National Electrical Safety Code
Interpretations
1978—1980 inclusive

**ANSI/IEEE C2
Interpretations 1978-1980**

National Electrical Safety Code Committee, ANSI C2

Fig IR 234

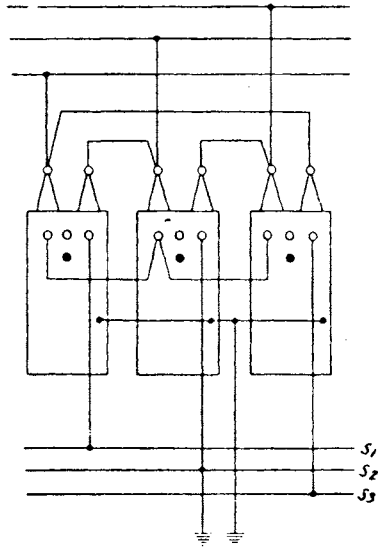
Question: "Can we use any one leg of the wye-secondary of the transformer bank as the neutral?"

The transformers in question are three single phase units (12470/277) connected delta on the 12 470 V side and wye on the low side for 480 V service. The common connection (the center of the wye) is floating and insulated from ground. One leg of the wye is grounded and used as the neutral. Three wires are carried to the motor starter. This installation is used for single three-phase motor service only.

The simple answer to the question is 'no' because grounding a phase conductor does not make it a neutral. The conductor would be a grounded phase conductor just as in the case of a corner grounded delta. Note that Part 2 of the Code is silent regarding grounding of phase conductors. The methods of Section 9 apply to situations where grounding is required by some other part of the Code. Rule 92B does not, therefore, apply to the situation.

Fig IR 280-1

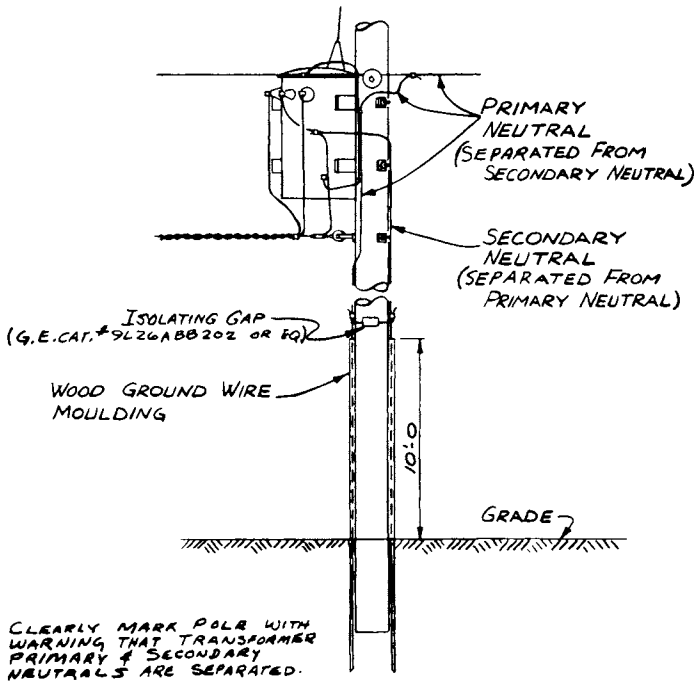
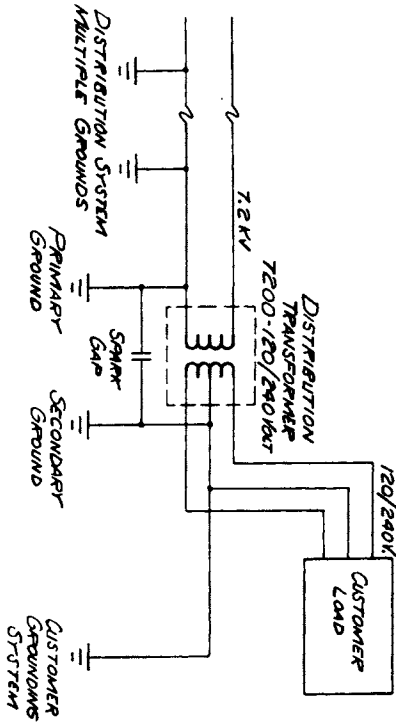
Does 97D. apply to the application? It appears 97D. is for an ungrounded primary system and not appropriate for the application.

- (1) Interpretation of secondary being single grounded, multi grounded or other type system.
- (2) Using a low voltage spark gap to interconnect the neutrals—presently we have a 6 kilovolt (kV) spark gap installed. Perhaps we should install a much lower voltage gap if one can be obtained.
- (3) For our particular application we would prefer having one secondary ground in the vicinity of the primary ground. The secondary ground would be installed considering step potential between grounding system.

The secondary system you describe is not a single grounded system per se. On the other hand it does not appear to qualify as a multiple grounded system under 96A3. Rule 97D does apply to your situation and a 10V spark gap would be required.

The secondary ground should be located a minimum of 20 ft from the primary ground to meet rule 97D.

Fig. IR 283

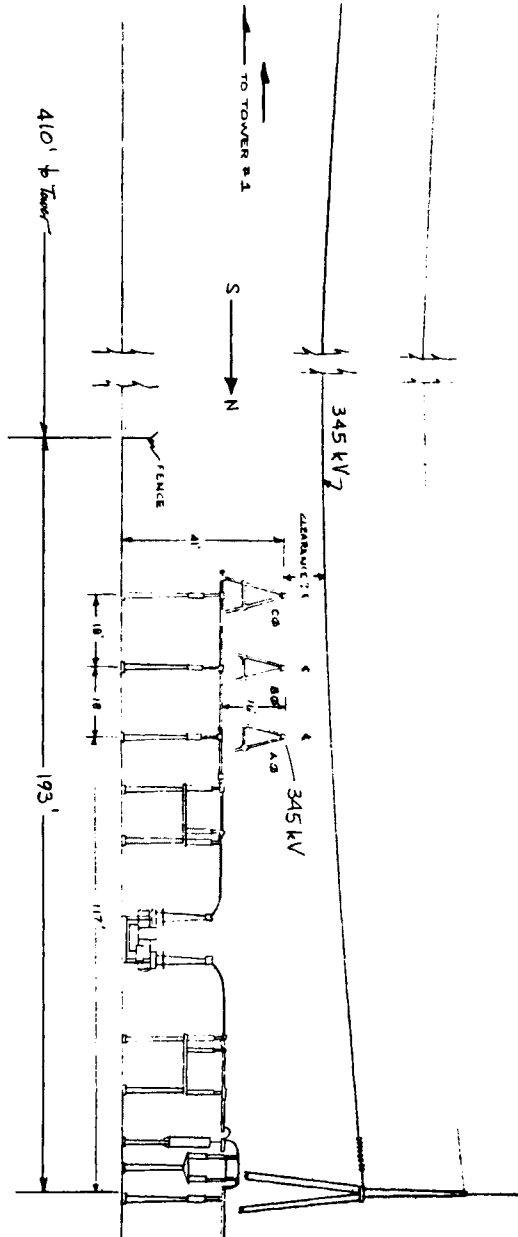
... presently installing a 345/69kV switchyard at ... Generating Station ... There are three (3) 345kV lines leaving the switchyard on the south side. The takeoff structures for these lines are located 193 ft north of the south fence line. The first transmission towers are located 410 ft south of the fence line. An east to west 345kV rigid bus, possibility of another circuit, is located 117 ft (A phase), 135 ft (B phase) and 153 ft (C phase) south of the takeoff structure and under the three 345kV transmission lines (see Fig IR 283). What is the required clearance between the transmission lines and the rigid bus?

An outgoing 345kV transmission circuit is perpendicular to, and crosses over, a 345kV rigid bus in a substation. This bus may not be of the same circuit. The major portion of the span, which rises to a higher elevation on another structure outside of the substation area, is outside of the substation fence. Is the clearance required between this outgoing feeder and the rigid bus in the station covered by Part 1 of the National Electrical Safety Code? If not, where is it covered by the Code and what clearance is required at final sag and at a conductor temperature of 176°F?

Part 1 of the Code does not specify the clearance requirements between conductors of an outgoing 345kV transmission line and rigid buses in a generating station.

Part 2 of the Code (Rule 233) may be used as a guide to determine the clearance if desired. In the absence of switching surge information, the straight line method should be used. The 60°F clearance would be the sum of 14.66 ft plus 75% of the mid span sag increase incurred between 60°F and 176°F. The 176°F clearance of 14.66 ft meets the requirements of Rule 233. Given the switching surge for the line, Table 233-2 might provide a somewhat lesser clearance.

Fig IR 240-1

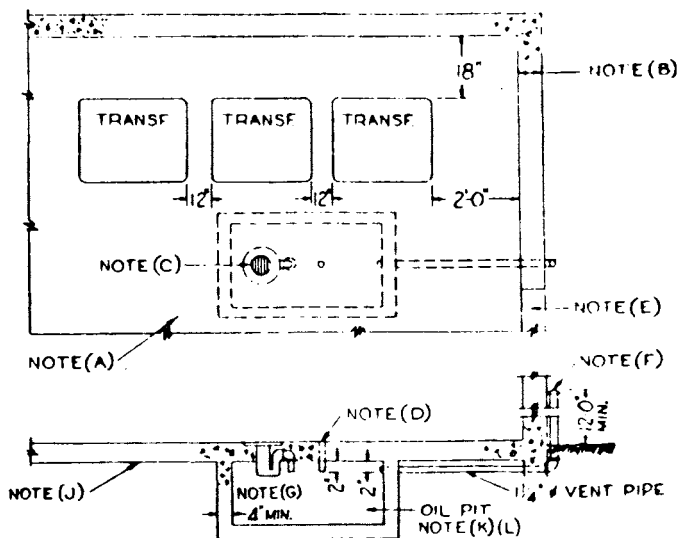
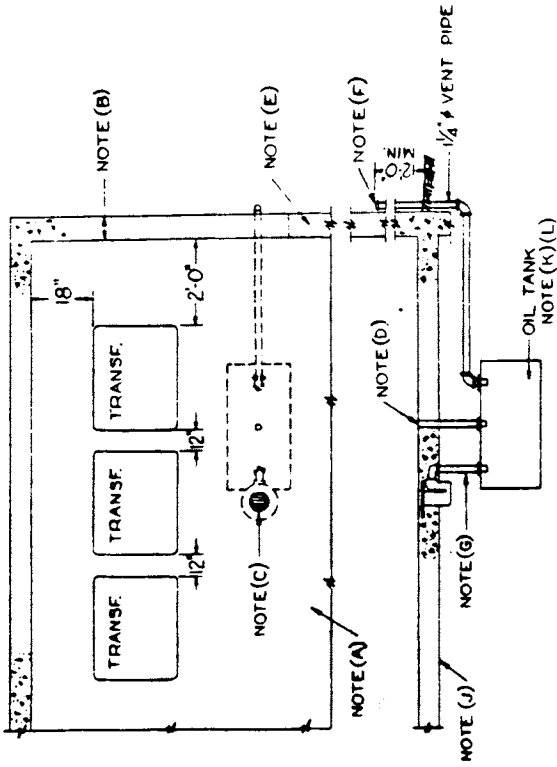
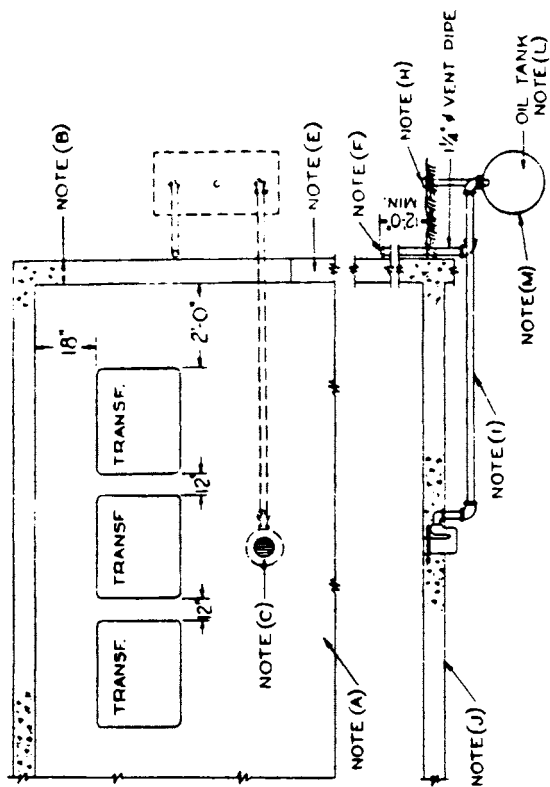
In Part 1, Section 15, Rule 153B1 of the 1977 Edition of the National Electric Safety Code, ANSI C2, when referring to indoor transformer installations, the code states "Floor drains shall be provided to carry oil to a safe location outside the building." Clarification is needed as to what is meant by outside of the building. Attached is a standard used . . . in the locating of oil containment facilities in conjunction with indoor customer transformer vaults. Please comment on whether or not each of the three installations diagrammed meets code requirements.

Fig IR 219

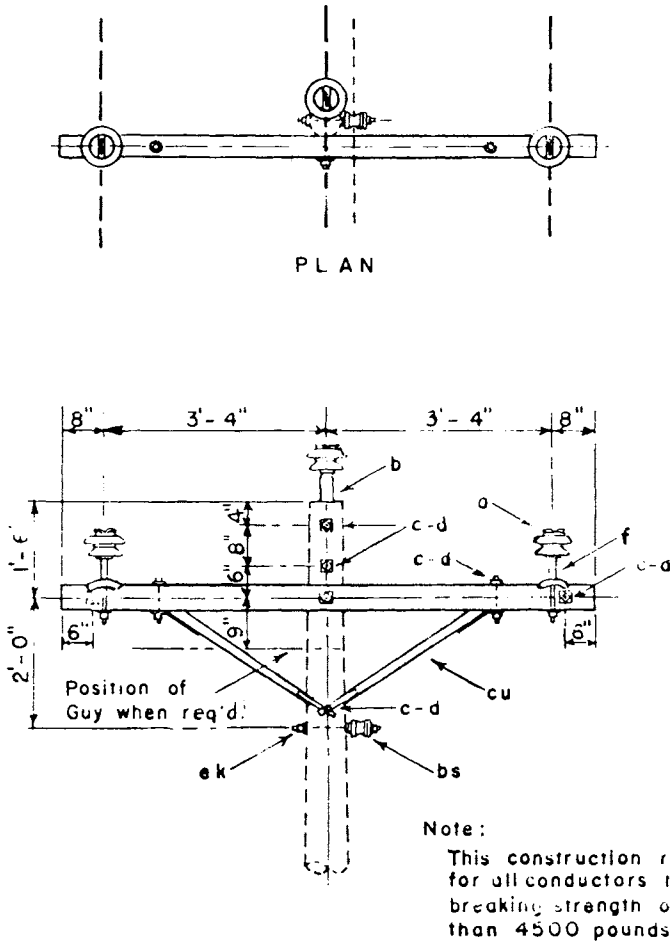
Therefore, our question is, does the replacement of 7.2/12.5 kV insulation constitute reconstruction and therefore require the line to meet the 1977 code requirements.

Fig IR 220

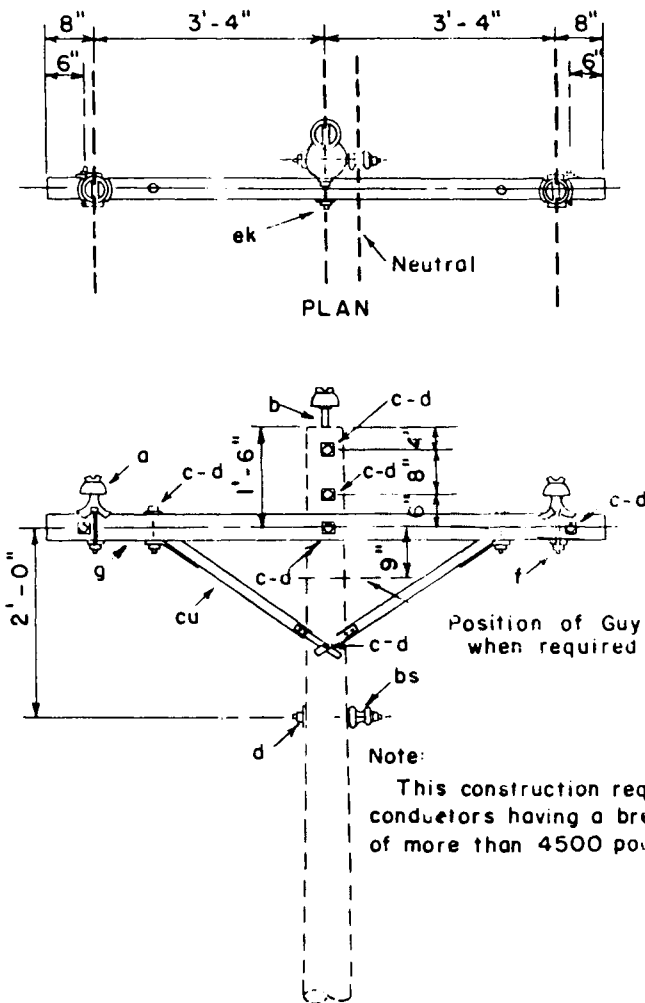
In the opinion of the Committee on Interpretations, are the conditions of application described hereafter considered "reconstruction" and therefore apply under Rule 202B1 or are they considered "ordinary maintenance" and therefore apply under Rule 202B2? The basic issue is whether or not a request and a granting of waiver from the proper administrative authority is required if during the line modification the conductor clearances are not to be brought up to conformance with clearance requirements of Part 2 of ANSI C2-1977.

The Interpretations Committee has carefully considered your question but has been unable to reach a consensus. Part of the committee believes that raising the voltage does not constitute reconstruction unless it is accompanied by an increase in the mechanical loading on the pole. Another view is that with every pole being worked on to change insulators and all transformers, capacitors, cutouts, etc., being replaced, this is more than mere maintenance. We are sorry we are unable to provide a clear-cut answer at this time; if the committee does reach agreement, we shall advise you accordingly.

Fig IR 243-1

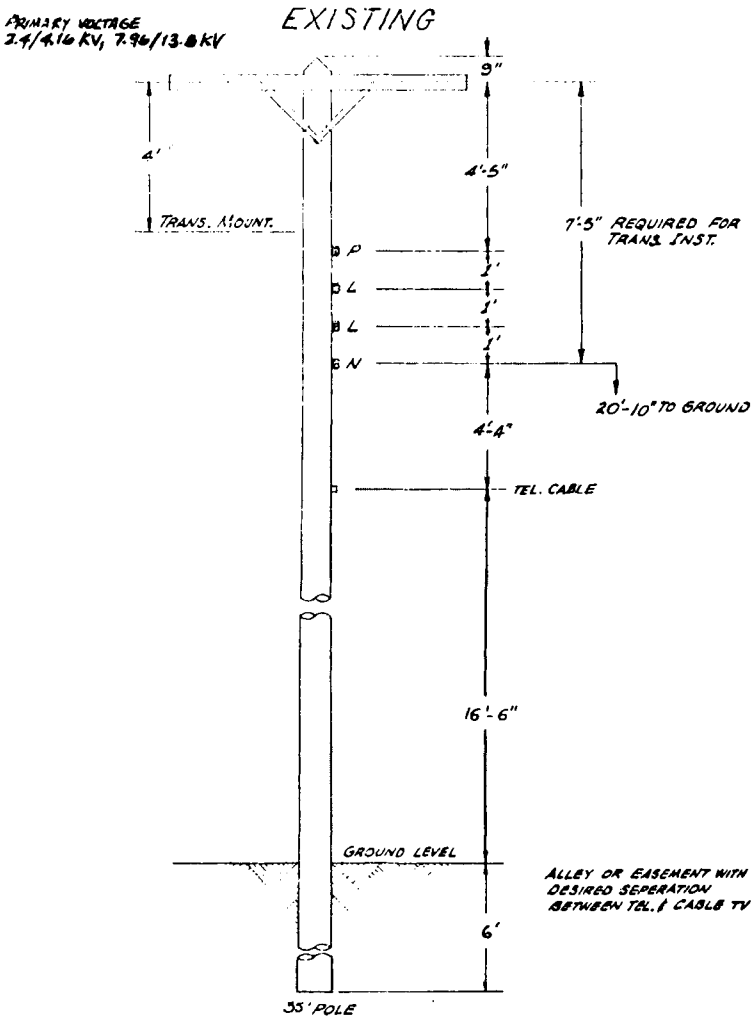
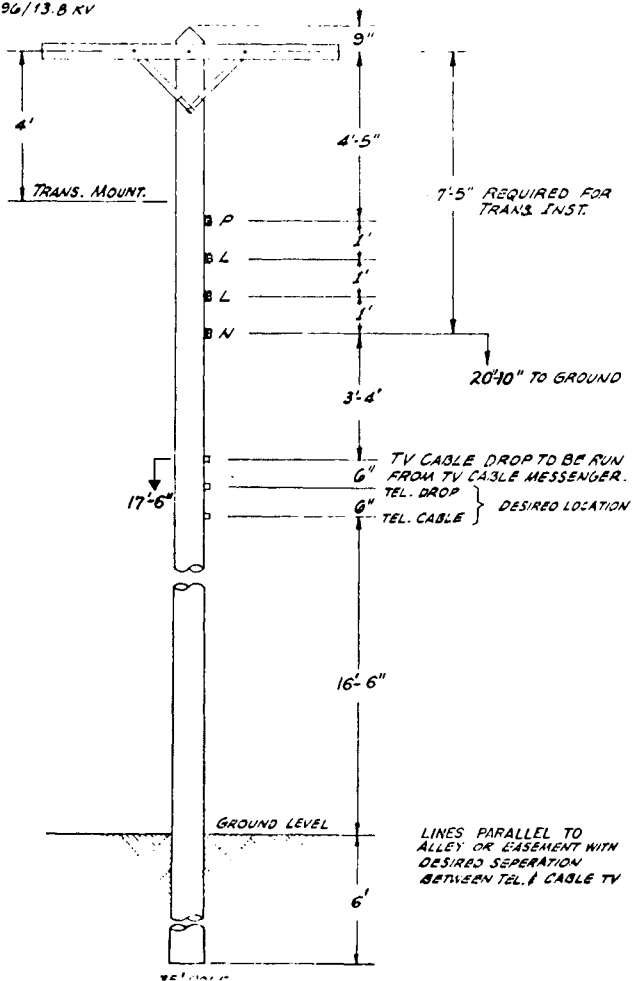
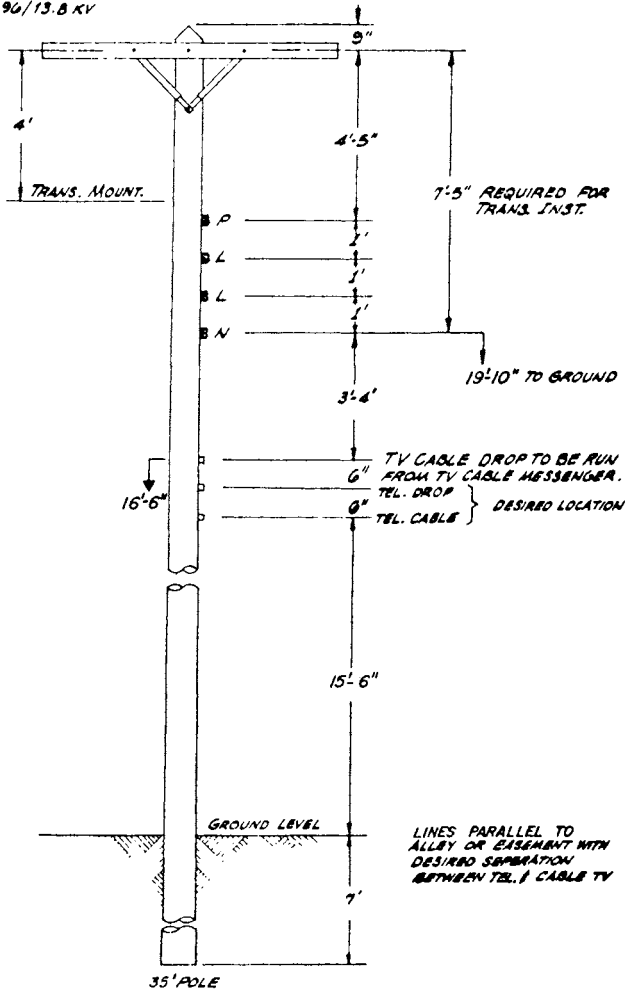
These clearances do not constitute a violation of those recommended by the National Electrical Safety Code; However, Texas Case Law requires that the neutral be treated as an energized phase conductor. The question you are being asked to resolve is, "does the addition of CATV cable and appurtenance, with no revision of electric facilities, constitute a change such that the pole should be reconstructed with the increased clearances specified in the 1977 National Electrical Safety Code?" Since Texas treats the neutral as a phase conductor, this would require for new installations, raising the neutral from 20 ft to 22 ft above grade for lines crossing public roads, streets, alleys, and parking lots subject to truck traffic.

- (4) Drawings of a present pole (Fig IR 243-1), a proposed pole (Fig IR 243-2), and a minimum clearance pole (Fig IR 243-3) follow. Fig IR 243-1 illustrates the dimensions given in the answer to item 3. Fig IR 243-2 shows the dimensions which would cover the majority of the 35 ft poles in our system, and these are as follows: From Grade to:
- (b) CATV Cable — 17 ft 6 in at pole.
 - (c) Neutral — 20 ft 10 in at pole.
 - (d) Secondary — 21 ft 10 in at pole.
 - (e) Primary — 20 ft at pole.

Addition of communication facilities to an existing jointly used line does not affect the ground clearance requirements for the electric power facilities. However, clearances between the added communications facility and the electric power facility must meet the requirements of Rule 235, (essentially the same requirements in the 1977 and 1973 Codes). Also, the line would have to meet the strength requirements of Rule 261 after the addition of the communication facilities.

Fig IR 246

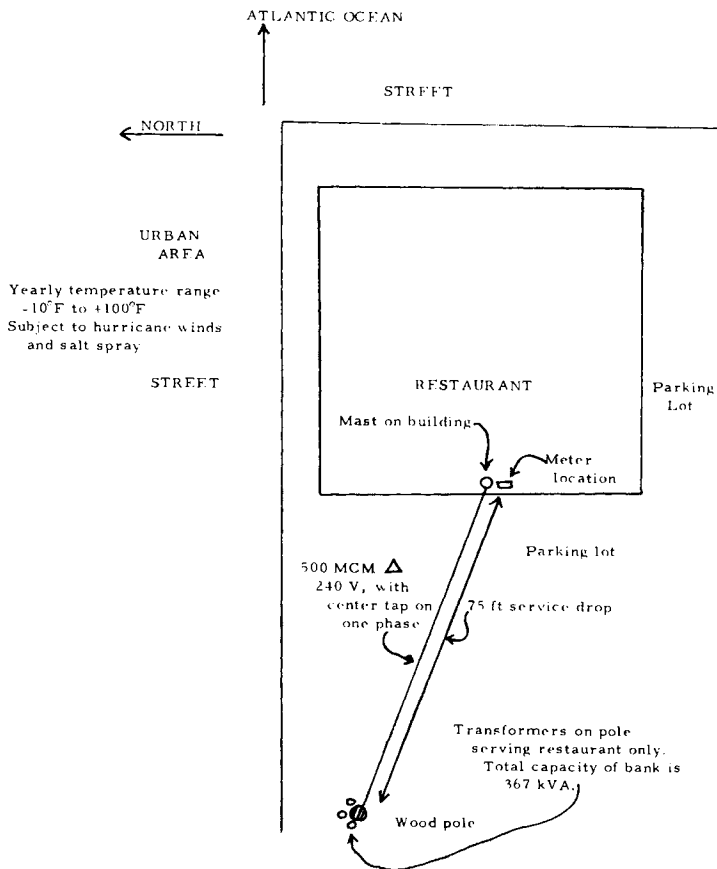
If there are no specific rules or known minimum standards for the frequency at which such an installation should be inspected and any defects recorded and/or acted upon, can you then advise what the general consensus is within the electric utility industry with regard to customary acceptable procedures and practices for systematic inspection of service drop installations such as the one pictured on the attached sketch.

Rule 214A2 states that inspection should be at such intervals as experience has shown to be necessary. The 'experience' referred to in the rule means, in general, the experience of the utility involved. The National Electrical Safety Code does not specify the fixed period of time, and the Interpretations Subcommittee cannot provide a specific answer.

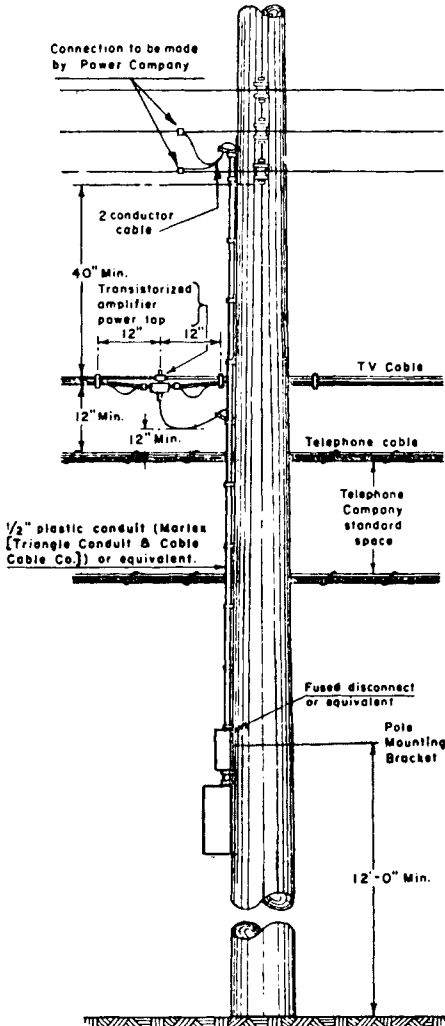
... [Fig IR 255 below] ... shows a typical arrangement of power line conductors, cable television, and telephone facilities on a common use pole. The 120 V power lead for the transistorized amplifier power tap is dimensioned as 12 in minimum between this power lead and the telephone cable below. Is this 120 V power lead a line conductor, a communications line, a vertical conductor, or a lateral conductor?

If the 120 V power lead is interpreted to be a line conductor, the required minimum clearance would be 40 in as specified in Table 235-5, column 1, line 1, or 16 in if the telephone and cable television companies comply with Rule 220B2.

Fig IR 277

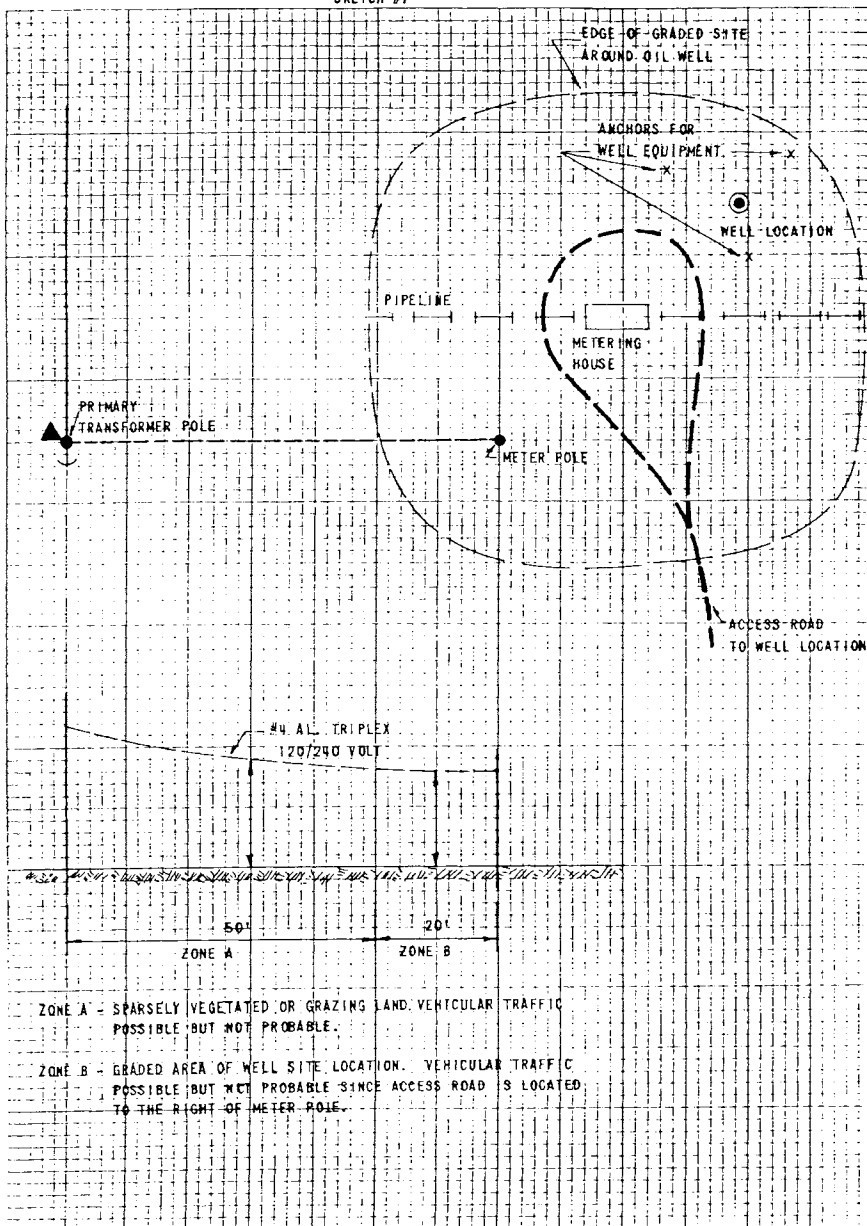
A question has arisen concerning the intended height for service wires to these installations.
